RECEIPT DATE: 10.19.22 **ONSITE SEWAGE DISPOSAL SYSTEM** P 572664

PROPERTY ADDRESS: 14740 McCann Farm Road

SUBDIVISION: McCann Estates - East LOT: 1 TAX ID: _____

RE: BAT Site Plan
McCann Estates - East (Lot 1)

MCCANN ESTATES - EAST (LOT 1)
 14740 MCCANN FARM ROAD WOODBINE MARYLAND 21797
 TAX MAP: B, BLOCK: 10, PARCEL: 27-A, LOT: 1
 FOURTH ELECTION DISTRICT
 HOWARD COUNTY, MARYLAND
SITE PLAN FOR BAT INSTALLATION

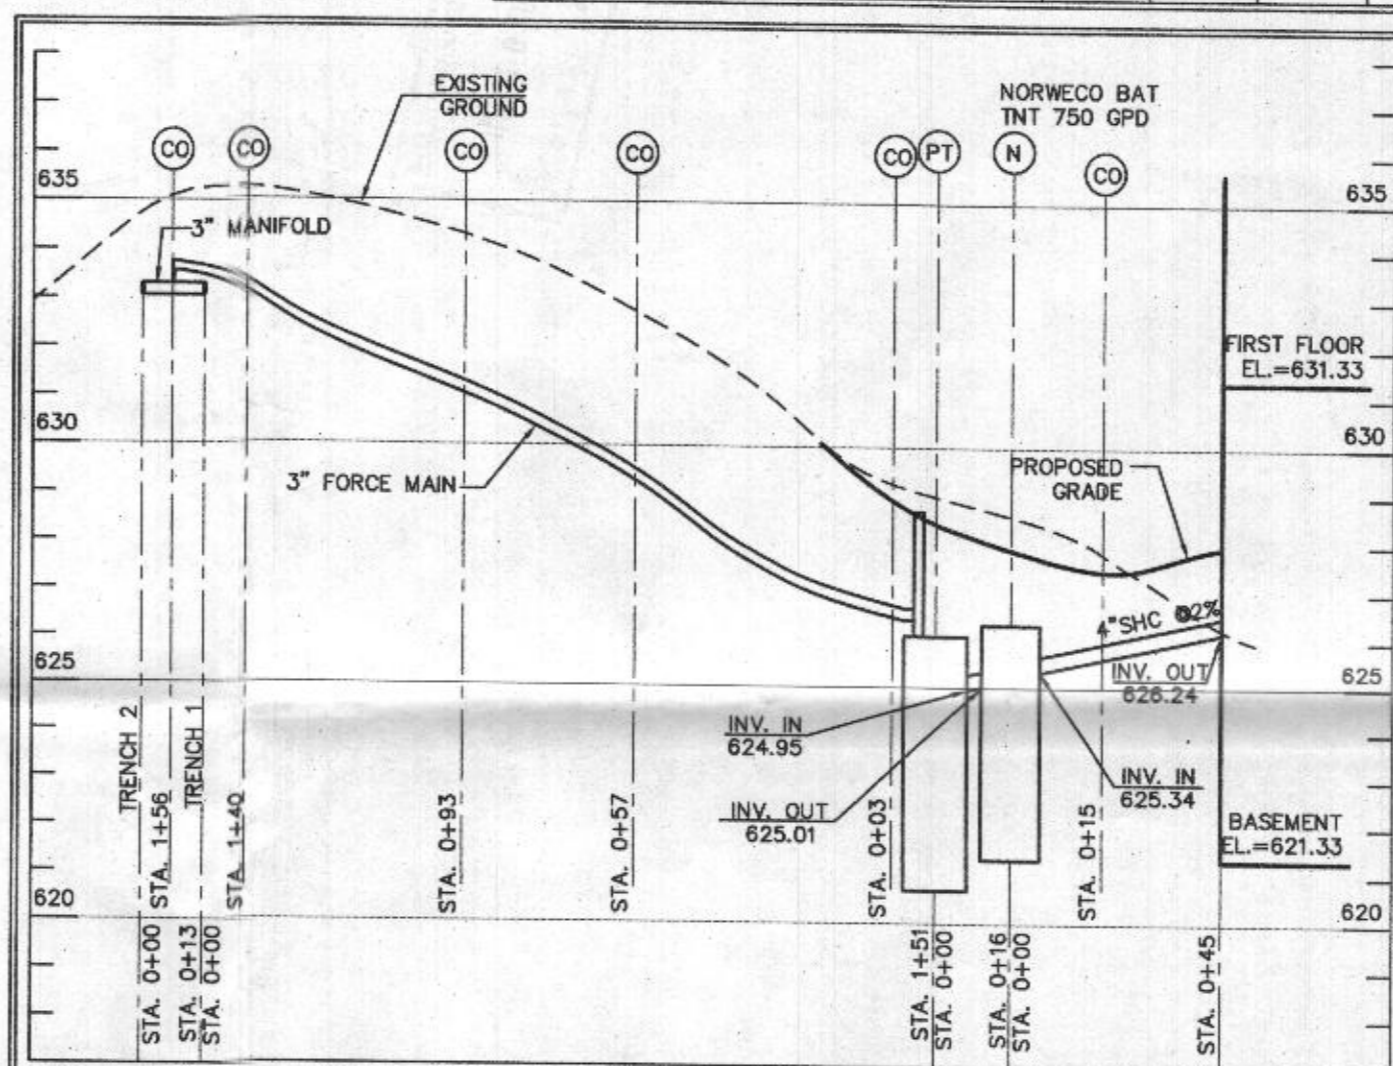
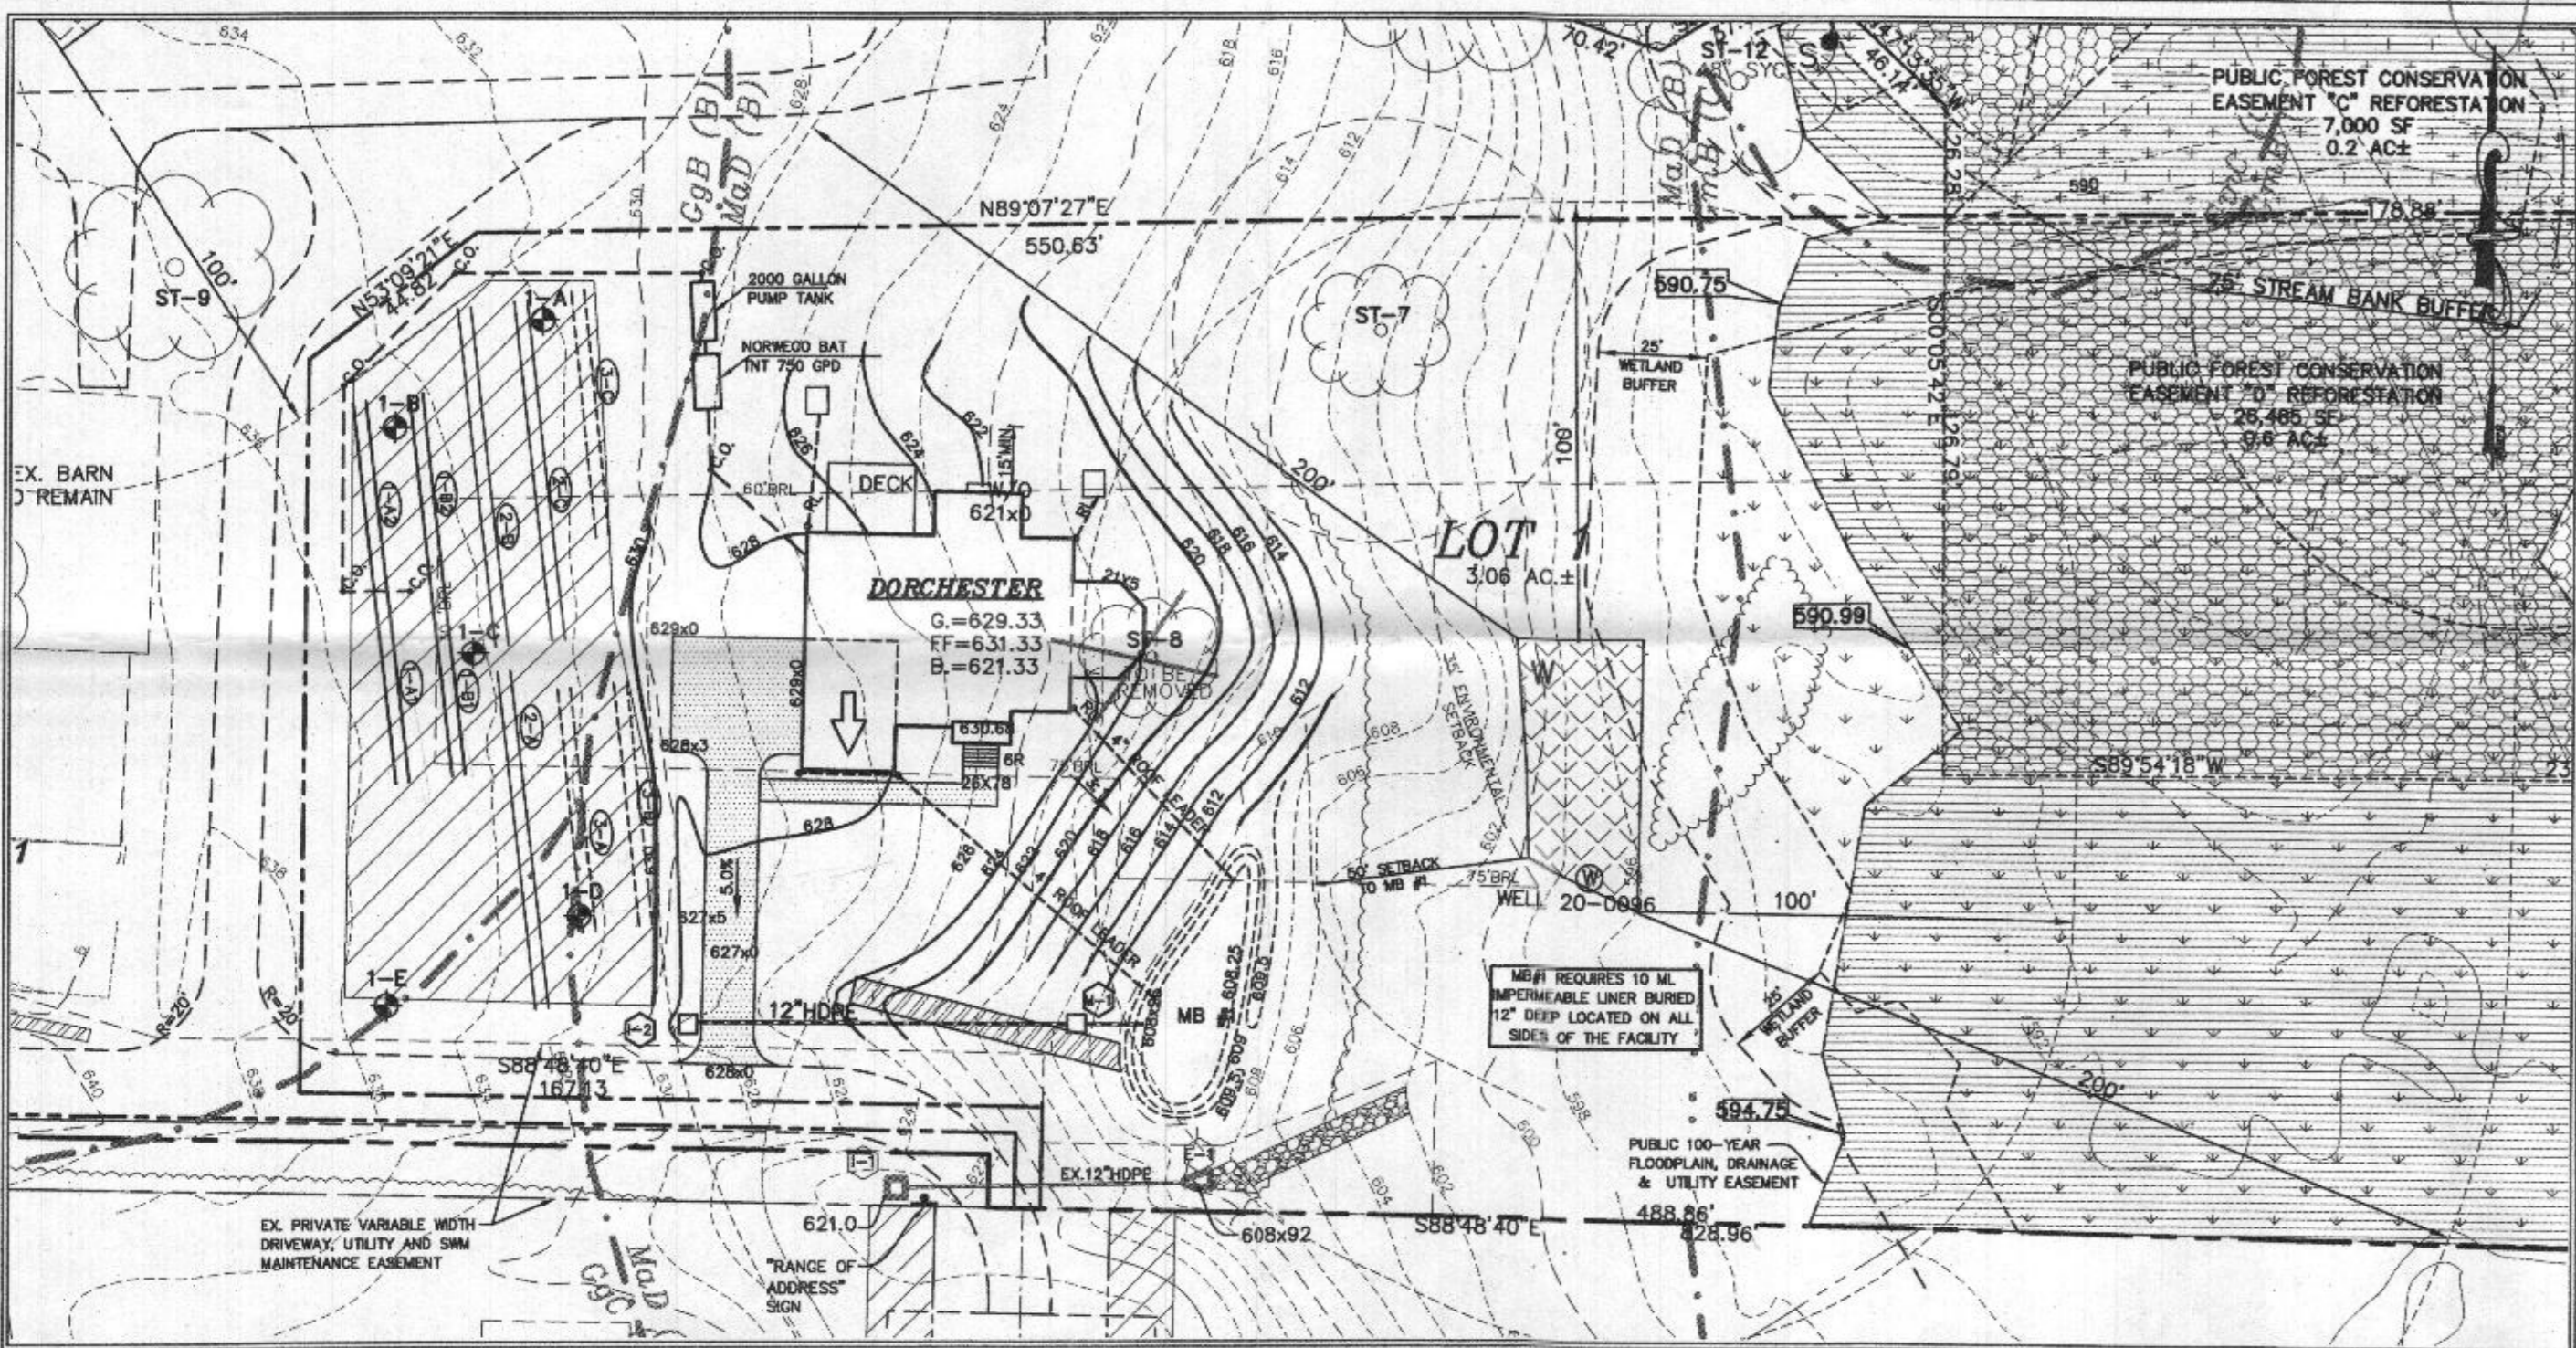
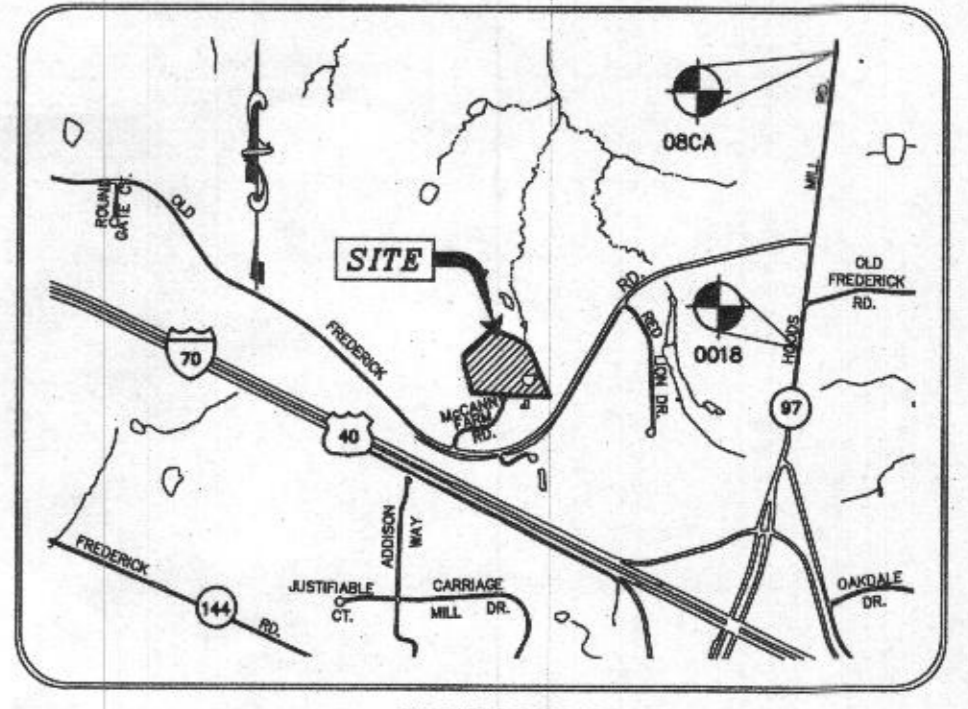
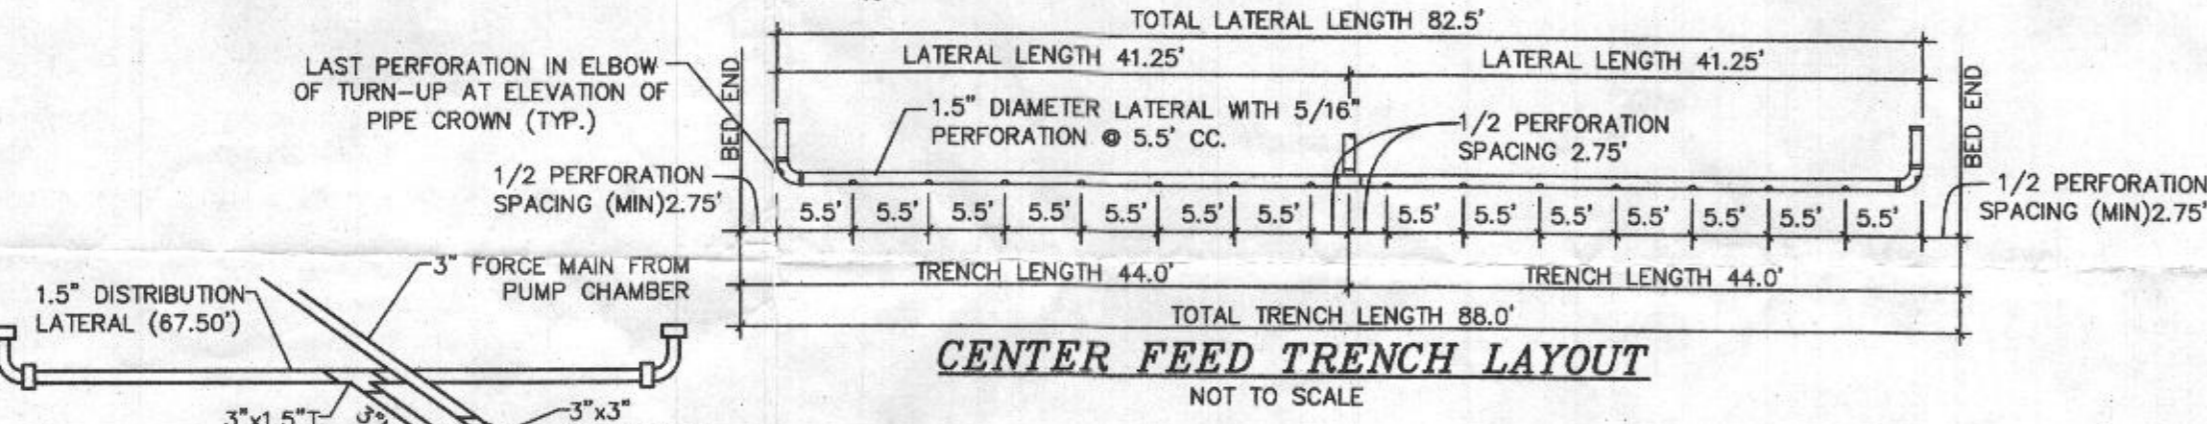
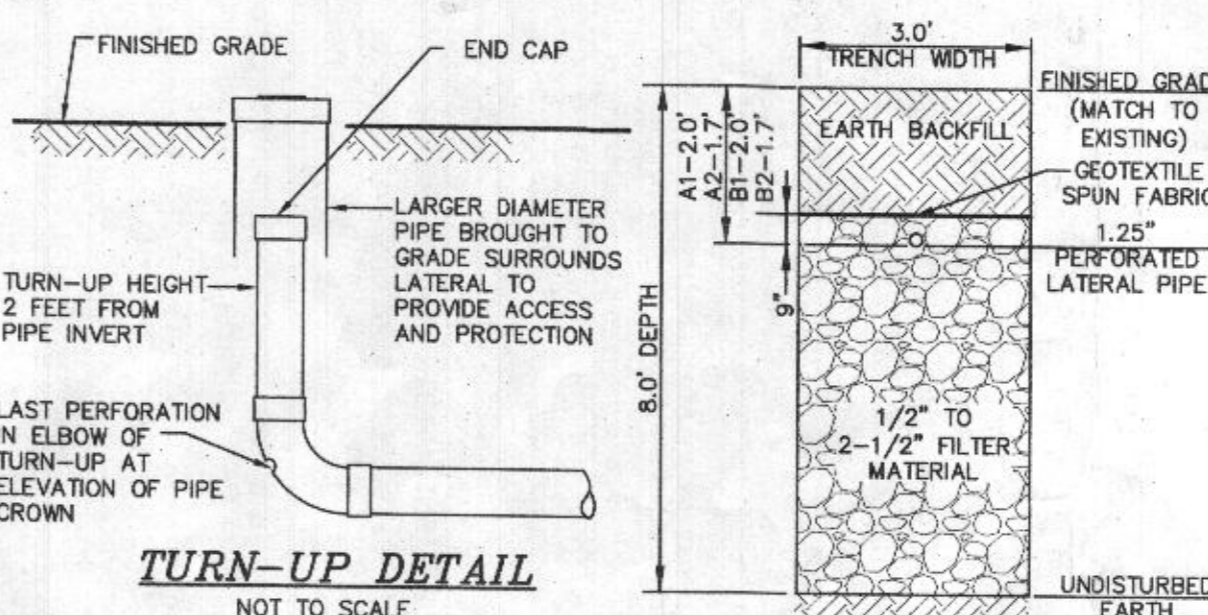
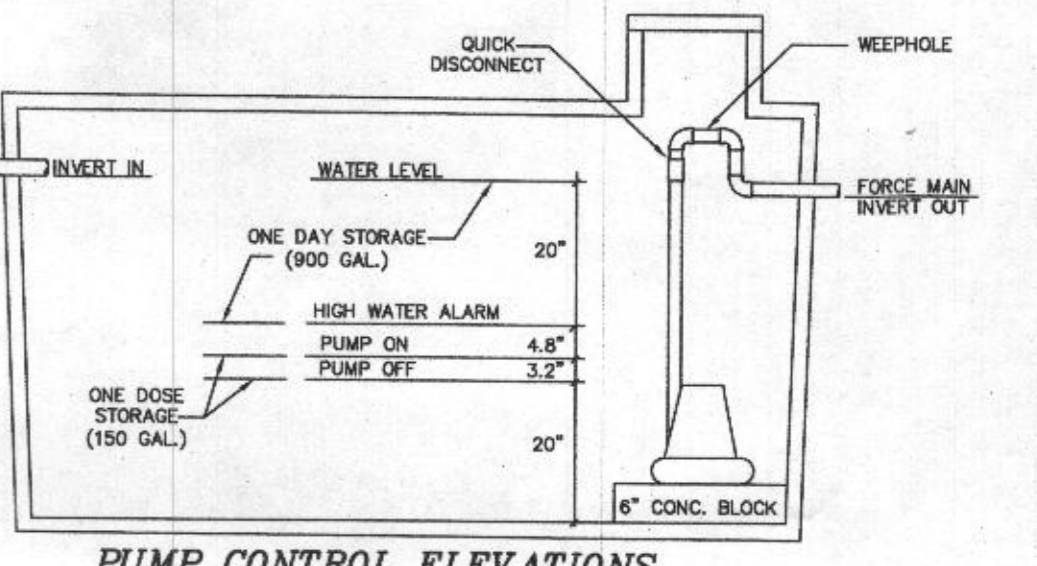
I reviewed the BAT plan for 14740 McCann Farm Road, and the charts don't reflect the new #s i.e. trench & lateral lengths. Also, I overlooked the swale graded over the proposed tank, and the drywells don't meet setbacks to the well (100 ft) or septic tank (25 ft).

- 1.) Trench Length = # of orifices x perforation spacing = $8 \times 5.5 = 44$ feet which aligns with the total length of trench (88 feet) being proposed in the schematic.
- 2.) Lateral Length = Trench Length – half a perforation spacing = $44 - 2.75 = 41.25$ feet
- 3.) Trench Flow Rate = 13.04 (not 13.4 as shown on chart)
- 4.) 2nd replacement system effective depth begins at 4 per septic specs (not 5 as shown on chart)
- 5.) The setback distance from a pond (MB-1) to the well box is 100 feet. If it has an impermeable lining, then the setback is 50 feet. Please clarify on plan.

- ✓ 1. Change title to, Site Plan for BAT Installation.
2. Make trenches more on contour particularly initial system and trench near hole 1-A.
- ✓ 3. Add emergency storage calculation to plan. (The pump chamber must have the capacity to accommodate a pump positioned on a six-inch riser, one dose volume, and one days design flow storage capacity above the high-water alarm.)
4. The length of trench shown on the *center feed trench layout* on plan is 80 feet (not 85 feet).
5. Make trench inverts the same depths (2 - 3 feet) and all inverts the same depths and head to simplify design (if possible).
6. Keep 2 trenches at required length, but separate them out into 4 trenches and 4 laterals with the following labels - 1A1, 1A2, 1B1, 1B2 (Please see attached LPD/Trench charts)
7. Add LPD chart to plan (see attached chart).
8. Min dose calc typo. Change 53.8 to 59.14.
